Official information request for COWELL, NZTA RESOURCE CONSENTS

Two decisions are attached. They are a land use consent being the construction of the St Leonards to Port Chalmers Shared Pathway Route, and the decision on the Outline Plan for separated cycle lanes.

**OUTLINE PLAN OUTLINE PLAN: OUT-2016-4
NZ TRANSPORT AGENCY
DUNEDIN SEPARATED CYCLE LANES (SH1)
DUNEDIN**

COPY OF PLAN: Not to Scale.

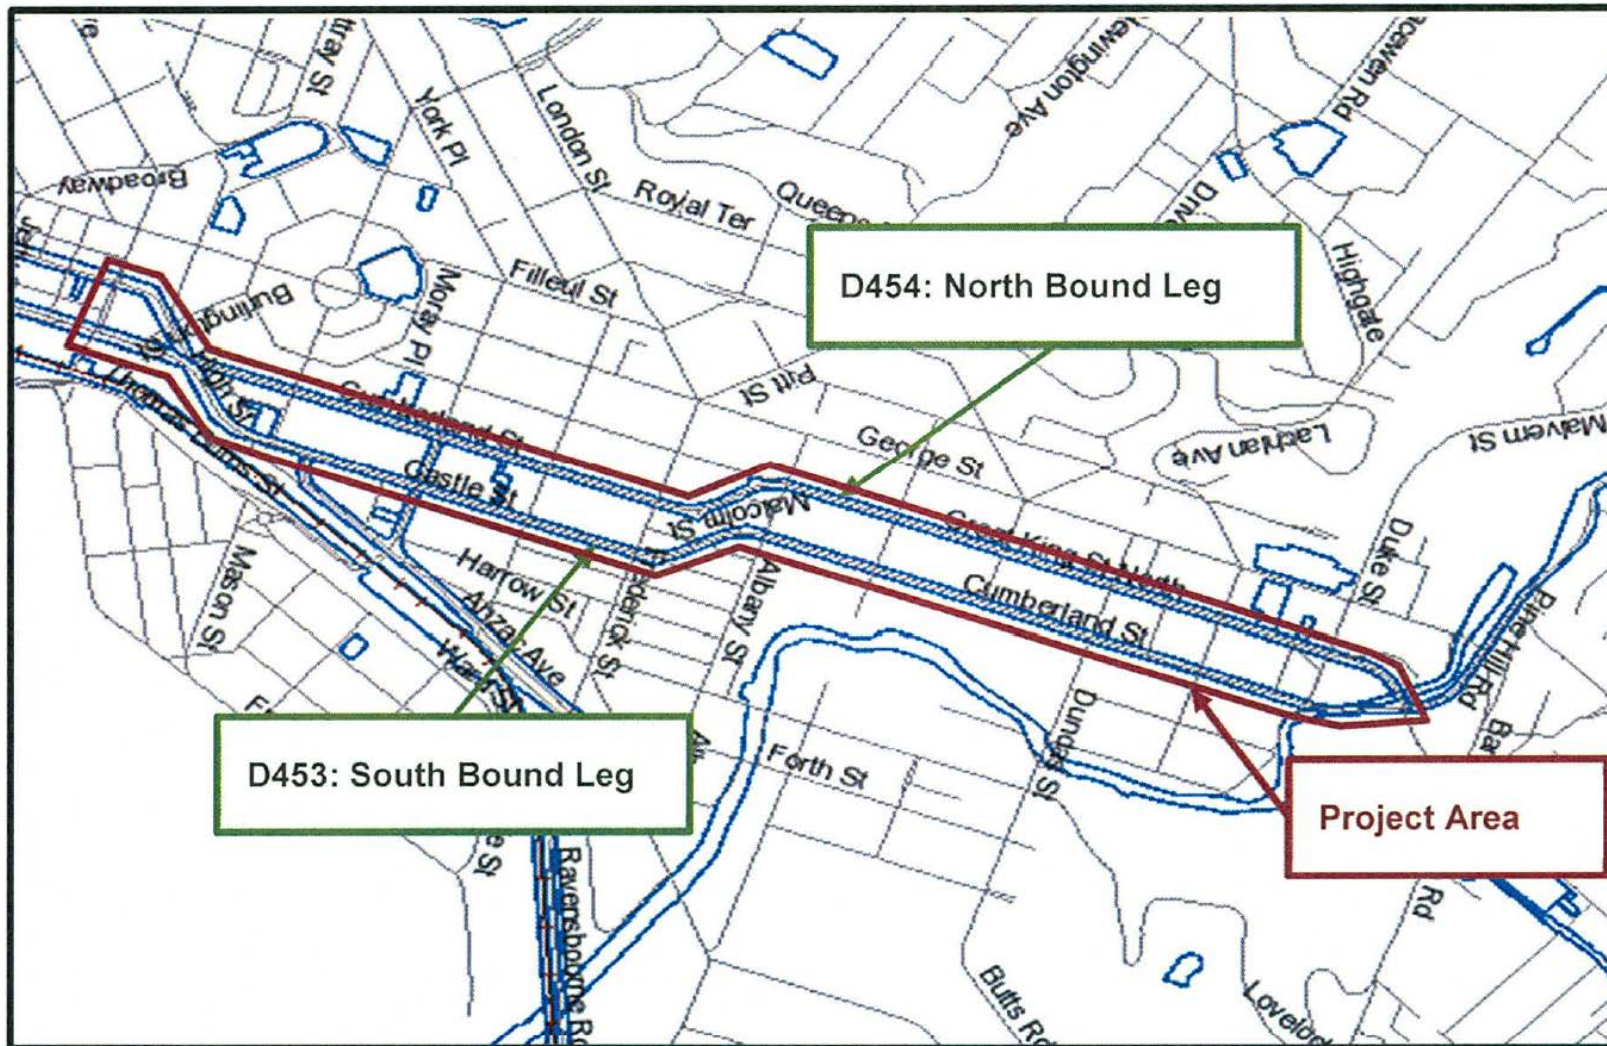
Pursuant to section 176A of the Resource Management Act 1991, the Dunedin City Council requests that the requiring authority carry out the proposed Dunedin Separated Cycle Lanes project on the One Way System (State Highway 1 – both northbound and southbound routes between Pine Hill Road and Rattray Street), Dunedin, in general accordance with the outline plan outline plan OUT-2016-4, except in regard to the changes listed below. The proposed work is described and shown on the following plans prepared by MWH New Zealand Ltd for the Dunedin One-Way System Separated Cycle Lanes:

1. *On-going consultation with Transport Group is maintained throughout the design phases of the project.*
2. *That matters raised in the memorandum dated 8 November 2016 to the NZ Transport Agency from Council's Transport Group are considered during the detailed design phase of the project.*
3. *That detailed engineering plans showing the construction design of all changes to transportation network, including footpaths, parking, and landscaping, and in particular any changes addressing the matters identified in the memorandum dated 8 November 2016, are to be submitted to the Group Manager Transport prior to construction commencing.*

4. *That the detailed design of cycle land infrastructure (traffic islands and footpaths, etc.) in relation to Council services should be submitted to the Water and Waste Services Business Unit prior to works commencing.*
5. *That the Water and Waste Services Business Unit is provided with a project timeline so that a more precise analysis of affected assets can be carried out.*
6. *That cycle lane infrastructure (traffic islands and footpaths) design should minimise conflict with Council water, wastewater and stormwater infrastructure as far as*

7. *That all valve covers (peat valves, sluice valves, etc.), manifold boxes, tobies, fire hydrant covers, etc. affected by the project should be adjusted so as to suit the finished level/s of the cycleway.*
